Name Of Dam: MIDDLETON DAM
Location: LEE COUNTY, VIRGINIA
Inventory Number: VA. NO. 10501

PHASE I INSPECTION REPORT

NATIONAL DAM SAFETY PROGRAM

BRIEF ASSESSMENT OF DAM

CLOSE-UP PRINCIPAL SPILLWAY

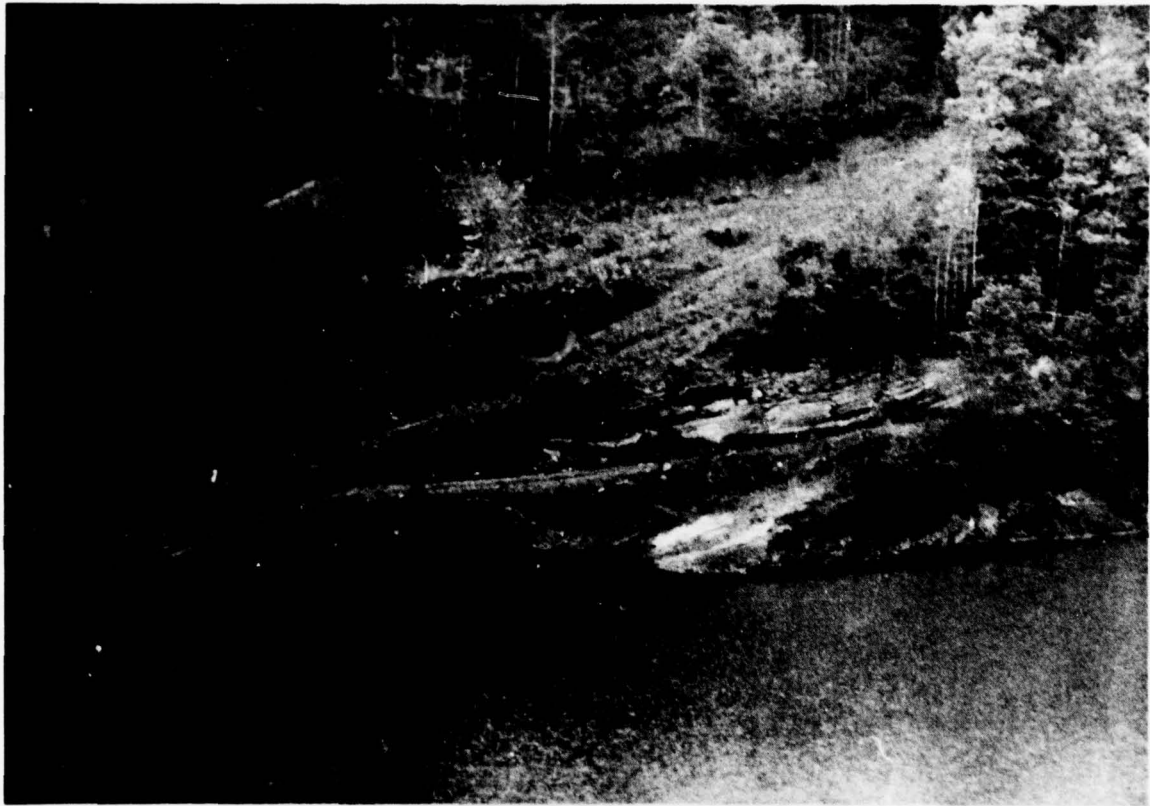
The principal spillway intake was clogged with leaves and small tree branches at the time of inspection. This was removed by the owner and the intake seemed to function at a small flow rate. The outlet of the principal spillway could not be seen; and according to the owner, the outlet was covered with large rocks and strip mine over burden. The drain gate valve was not inspected.

(NOTE: TRASH ON TOP)

7.2.3 Strip mine waste debris should be removed from over the outlet pipe to allow a free flowing condition during increased lake levels.

PHOTOGRAPH EMERGENCY SPILLWAY

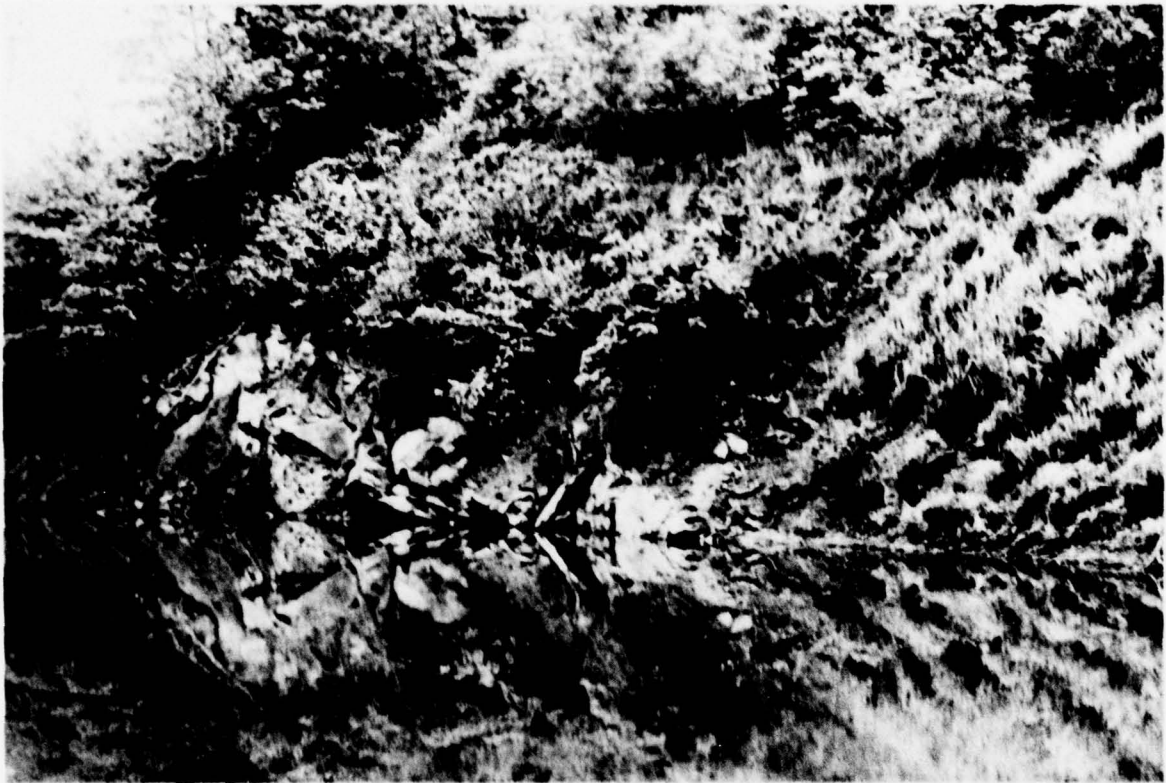
The emergency spillway is located at the right abutment. The left side of the emergency spillway is at a slope of 1.5:1 and in fill. The right side of the spillway is at a 1:1 slope and is in cut. Previous erosion reported by the owner had been repaired.

7.2.2 The emergency spillway should be modified to accommodate the $\frac{1}{2}$ PMF without overtopping the dam.
